**Comment Response Matrix
for
Nuclear Regulatory Commission (NRC)
Requests for Additional Information (RAIs) on the
Saltstone Disposal Facility Performance Assessment
(SRR-CWDA-2009-00017, Revision 0, dated October 29, 2009)**

Prepared by: Savannah River Remediation (SRR)
Closure & Waste Disposal Authority
Aiken, SC 29808

Prepared for U.S. Department of Energy Under Contract No. DE-AC09-09SR22505

**Figure PA-2.1: Peak Mean Dose to a MOP, Any Sector- Case E
(modified from Figure 5.6-38 in SDF PA)**

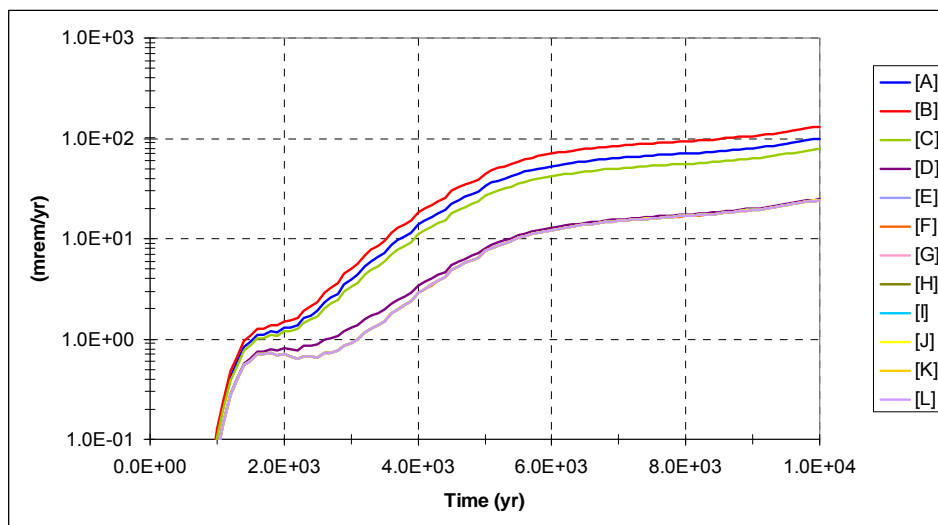
<p><u>PA-2</u></p>	<p>Probabilistic sensitivity analyses were not provided for cases representing bulk saltstone degradation.</p> <p><u>Basis</u></p> <p>Probabilistic sensitivity analyses were performed only for Cases A and C. Although Case C represents a fast flow pathway through saltstone, neither Case A nor Case C represents degradation of the bulk saltstone matrix. Case E, which represents saltstone degradation, was not included in the sensitivity analysis. Dose sensitivities in a case with degraded saltstone are expected to be different from the sensitivities in a case without degraded saltstone. For example, because chemical transitions would be achieved earlier in a case in which bulk saltstone has a greater hydraulic conductivity, parameters affecting the transport of radionuclides sensitive to pH transitions in saltstone may have a greater effect on dose. Similarly, parameters related to slower-moving radionuclides (e.g., plutonium) may have a more significant effect on dose in a case in which more water moves through the bulk saltstone. The sensitivity of these parameters is important to identifying issues that should be tracked during monitoring.</p> <p><u>Path Forward</u></p> <p>Provide a probabilistic sensitivity analysis for a case that reflects saltstone degradation, or explain why the sensitivity analyses performed in the PA are expected to reflect the sensitivities of dose in a case that reflects saltstone degradation. If a new sensitivity analysis is performed, it should be consistent with any modifications made in response to the comments in this document.</p>

<p><u>RESPONSE PA-2:</u></p> <p>This response provides results for the probabilistic uncertainty and sensitivity analysis for the severely degraded saltstone Case E over 10,000 years. Degraded saltstone is assumed to take the form of cracked grout and has been modeled by increasing its hydraulic conductivity to a value of 1.7E-3 cm/sec.</p> <p>As emphasized in SDF PA Section 5.6.4, the results of the uncertainty and sensitivity model are not intended to predict future potential dose for comparison to performance objectives (the SDF PORFLOW model has been used for assessment of peak doses versus performance objectives). Rather, the goal of this SDF modeling is to characterize the context of uncertainty and sensitivity surrounding the PA calculations involving doses to MOP exposed via groundwater. Case E is an extreme case based on the very high hydraulic conductivity value used, which is approximately two orders of magnitude higher than backfill soil. The relative influence of Case E on the composite "AllCases" result is evident by comparing Figure PA-2.1 and Figure PA-2.2 below.</p>

Figure 1: Moisture characteristic curves adapted from the PA and WSRC-STI-2006-00198

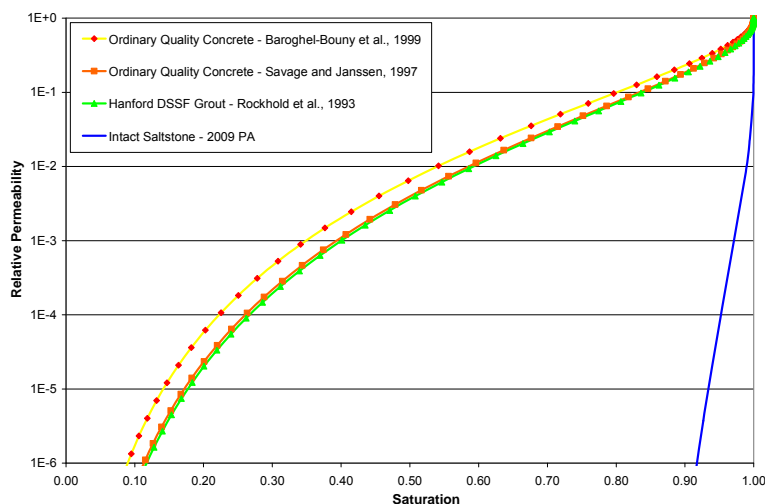
The PA implements curves substantially different from those found in literature. For example, the curves in the PA are significantly different from the curves discussed in *"Hydraulic Property Data Package for the E-Area and Z-Area Soils, Cementitious Materials, and Waste Zones"* (WSRC-STI-2006-00198) (Figure 1). The moisture

<p>characteristic curves discussed in WSRC-STI-2006-00198, which were derived by Rockhold et al. (1993), Savage and Janssen (1997), and Baroghel-Bouny (1999) for different cementitious materials by different methods, all have very similar characteristics. The similarity of the curves is significant because the curve derived by Rockhold et al. (1993) was based on a Hanford double-shell slurry feed (DSSF) grout formulation that is very similar to saltstone (WSRC-STI-2006-00198). Both saltstone and the DSSF grout consist of approximately 47% blast furnace slag, 47% fly ash, and 6% Portland cement with similar salt concentrations (WSRC-STI-2006-00198).</p> <p>Difficulties with experimental methods introduced additional uncertainty into the characteristic curve for saltstone implemented in the PA. The curve developed in <i>"Numerical Flow and Transport Simulations Supporting the Saltstone Disposal Facility Performance Assessment"</i> (SRNL-STI-2009-00115) is based on experiments conducted at the Idaho National Laboratory (INL) which experienced experimental challenges that are not typically encountered in traditional soil and rock testing, as discussed in <i>"Hydraulic and Physical Properties of MCU Saltstone"</i> (WSRC-STI-2007-00649). These challenges resulted in the following non-standard conditions which introduce uncertainty into the results: (i) modification of standard tests, (ii) inconsistent sample preparation, (iii) hydraulic analyses being obscured by the generation of gas within the saltstone samples, (iv) inability to meet the requirements of minimizing the effects of the matrix potential gradient for the samples, (v) limited drainage of the samples, and (vi) the assumption of a residual moisture retention value in the samples that is in contrast with the literature (WSRC-STI-2006-00198; Vanapalli, 1998).</p> <p>Case E and the increased hydraulic conductivity case discussed in Section 5.6.6.7 address the uncertainty in flow through saltstone by assuming it the bulk saltstone to be degraded. Cases B-D and the synergistic case address uncertainty in the flow through saltstone by assuming saltstone to be fractured. However, due to the uncertainty in the characteristic curves for intact saltstone and fractured saltstone, as discussed in this comment and comment SP-4, it is not clear how conservative these sensitivity cases are. In addition, because the base case result is an important factor for compliance determination, it is important to be able to support assumptions about the characteristic curves used for the base case.</p> <p><u>Path Forward</u></p> <p>Provide additional justification for the moisture characteristic curve for intact saltstone implemented in the PA model by addressing the experimental sources of uncertainty described in the basis. Alternately, provide updated results of Cases A, B, C, D, the synergistic case, and the sensitivity case in Section 5.6.6.7 that use a characteristic curve for intact saltstone that is more consistent with results in the literature. Any updated analysis should be consistent with the response to SP-4.</p>

Figure 2: Characteristic curves for the intact and fractured saltstone and concrete as adapted from the 2009 PA and SRNL-STI-2009-00115

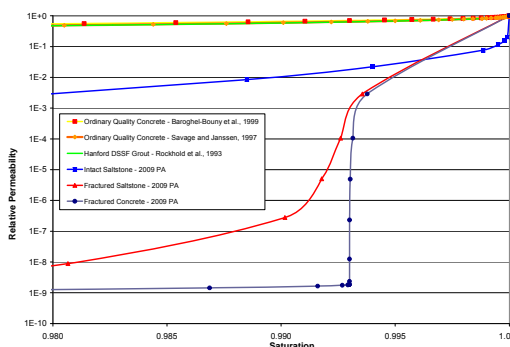
Characteristic curves implemented in the PA are based on a continuum approach that does not reflect non-equilibrium flow.

The characteristic curves developed by INL (referred to in SP-3) were also used as the basis for the fractured saltstone and concrete characteristic curves (see Figure 2 below) that were developed in “*Numerical Flow and Transport Simulations Supporting the Saltstone Disposal Facility Performance Assessment*” (SRNL-STI-2009-00115). The authors discuss the use of an analytical approach developed by Or and Tuller (2000) to adapt INL moisture characteristic curves for cracked cementitious materials because experimental characteristic data for cracked vault concrete and saltstone grout are not available (SRNL-STI-2009-00115). However, use of moisture characteristic curves combined with coarse spatial and temporal averaging can result in an inadequate representation of non-equilibrium flow.

Provide additional support for the modeled flow through fractures. Model support could include field observations and laboratory experiments that verify consistency between numerical results and physical measurements.

Figure SP-6.1: Calculated Peclet Number for SDF PA Case A

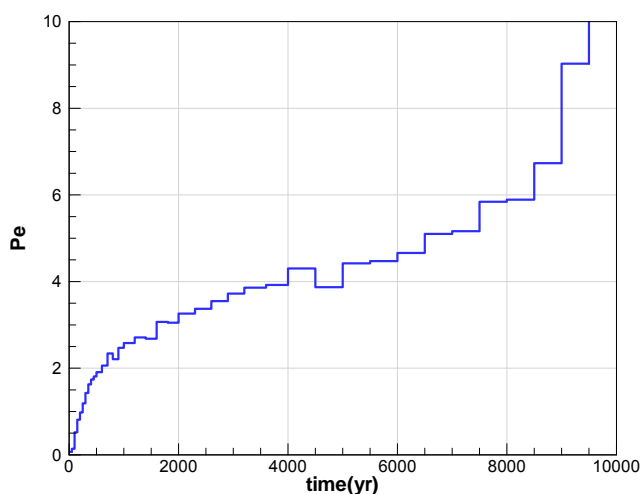
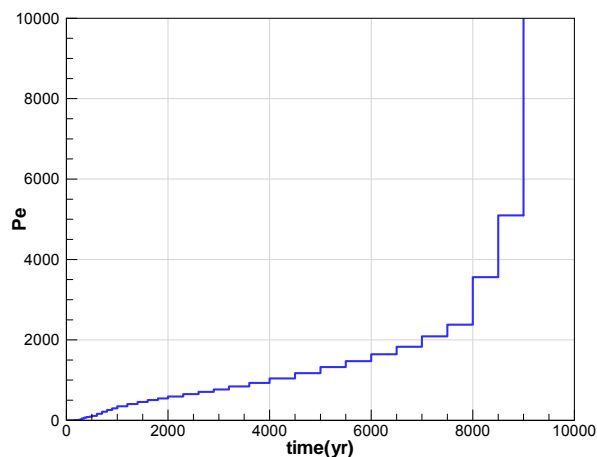
<p><u>SP-6</u></p>	<p>Comment: Additional basis is required for the values of the effective diffusivity of intact and degraded saltstone used in the base case and sensitivity cases.</p> <p><u>Basis</u></p> <p>As discussed in comment SP-1, the effects of degradation of bulk saltstone (as compared to fractures in otherwise intact saltstone) are addressed in sensitivity Case E, in the synergistic case discussed in Section 5.6.6.5, and in an increased saltstone hydraulic conductivity case discussed in Section 5.6.6.7. In each of these cases, the hydraulic conductivity of saltstone is adjusted, but the effective diffusivity is kept constant at the base-case value. Because both the effective diffusion coefficient and hydraulic conductivity are intimately related to pore structure in cementitious materials, it is reasonable to expect that both coefficients would increase as saltstone degrades. The basis for adjusting the hydraulic conductivity in the sensitivity cases but maintaining the effective diffusivity at the base-case value does not appear to be addressed in the PA.</p> <p>In addition, clarification is needed of the basis for the effective diffusivity of intact saltstone. The supporting document "Numerical Flow and Transport Simulations Supporting the Saltstone Disposal Facility Performance Assessment" (SRNL-STI-2009-00115) indicates that the effective diffusivity is based on a comparison to other cementitious materials with similar hydraulic conductivities, but the specific materials used for comparison and the process by which an effective diffusivity value was selected are not provided. Table 4.4-16 of the PA indicates that the effective diffusion coefficient is based on the effective diffusion coefficient of high quality concrete in the supporting document "Hydraulic and Physical Properties of Saltstone Grouts and Vault Concretes" (WSRC-STI-2006-00198). However, the actual value of the effective diffusion coefficient for high quality concretes provided in Tables 6-44 and 6-47 of WSRC-STI-2006-00198 is 5 E-8 cm²/s, which does not match the value of 1.0 E-7 cm²/s used in the PA for saltstone. Furthermore, it is not clear why an effective diffusivity value appropriate for high quality concrete, which has a porosity of 0.11 (PA Table 4.2-16) would be appropriate for saltstone, which has a porosity of 0.58 (PA Table 4.2-16). While the choice of an effective diffusion coefficient of 1.0 E-7 cm²/s is more pessimistic than the value provided for high quality concrete in the supporting document, the basis for the effective diffusivity value chosen should be clarified.</p> <p><u>Path Forward</u></p> <p>Provide a basis for using the effective diffusivity of intact saltstone in the two sensitivity cases that address degraded saltstone listed in the basis or update the sensitivity cases that address degraded saltstone with a value of effective diffusivity that reflects the physical degradation of the wasteform. Clarify the basis for the value of the effective diffusivity of intact saltstone.</p>

<p><u>RESPONSE SP-6:</u></p> <p>While the diffusion coefficient would be expected to increase as the saltstone degrades, the transport is advection dominated except during the first few hundred years after closure as indicated by the Peclet number for Case A for Vault 4 as presented in Figure SP-6.1. As indicated in Figure 5.5-1 in the SDF PA, the peak dose in 10,000 years is in Sector B at year</p>

10,000 and is dominated by releases from Vault 4. At year 10,000 the Peclet number is greater than 10 indicating the dominance of advective versus diffusive transport. Therefore, any change in the diffusion coefficient will not have a noticeable impact on the calculated peak dose results.

Similarly, for Case E (the configuration case with significantly degraded saltstone properties) Figure SP-6.2 presents the Peclet number for Vault 4 within 10,000 years. As indicated in Figure 5.6-72 in the SDF PA, the peak dose in 10,000 years is in Sector B at approximately year 9,400 and the Peclet number is greater than 10,000 indicating the dominance of advective versus diffusive transport. As in Case A, any change in the diffusion coefficient will not have a noticeable impact on the calculated peak dose results.

Figure SP9-1: pH Evolution as CSH is Reached

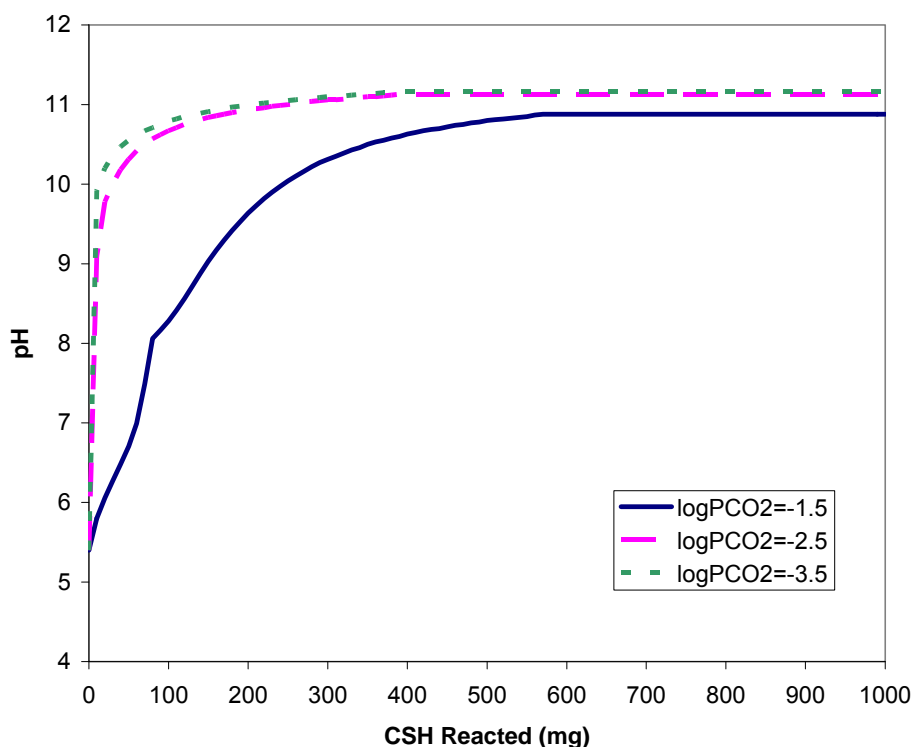
Clarify the basis for the selected groundwater composition used in SRNL-TR-2008-00283, addressing how well it represents the chemistry of water in the unsaturated zone. Alternately, provide information showing the effect of variation in SRS groundwater composition on the Eh and pH transitions, including any expected differences between the chemistry of the water samples addressed in WSRC-RP-92-450 and water in the unsaturated zone, is bounded by the estimated ± 50 percent uncertainty in Eh and pH transition pore volumes. Provide reference WSRC-RP-92-450.

The composition of a water table well that is screened in a lithology that is similar to the unsaturated zone is likely to be a good estimate of the unsaturated zone pore water composition. The primary difference might be the dissolved O_2 and CO_2 concentrations. The dissolved O_2 concentration is addressed above. Partial pressures of CO_2 in soil gas are often higher than atmospheric and this is reflected in the P27D groundwater composition. The calculated $\log PCO_2$ is -2.6 compared to -3.5 for $\log PCO_2$ of the atmosphere. At the pH of the groundwater, variations in PCO_2 do not significantly change the groundwater pH. Nor do variations in PCO_2 significantly alter the equilibrium pH of CSH reacted with the groundwater. Figure SP9-1 shows the pH evolution as CSH is reacted with a groundwater at pH 5.4 at different $\log PCO_2$ values. The equilibrium pH is identical for $\log PCO_2$ values of -3.5 and -2.5. For $\log PCO_2 = -1.5$ the equilibrium pH of CSH is 10.9. What does change is the amount of CSH dissolution required to reach equilibrium. Again, this is nearly identical for $\log PCO_2$ values of -3.5 and -2.5, but is about 50% more for $\log PCO_2 = -1.5$. Thus, if there were a rather extreme partial pressure of CO_2 in the unsaturated zone it could reduce the transition time from Region II to Region III. However, there is no reason to expect such a condition at the SDF.
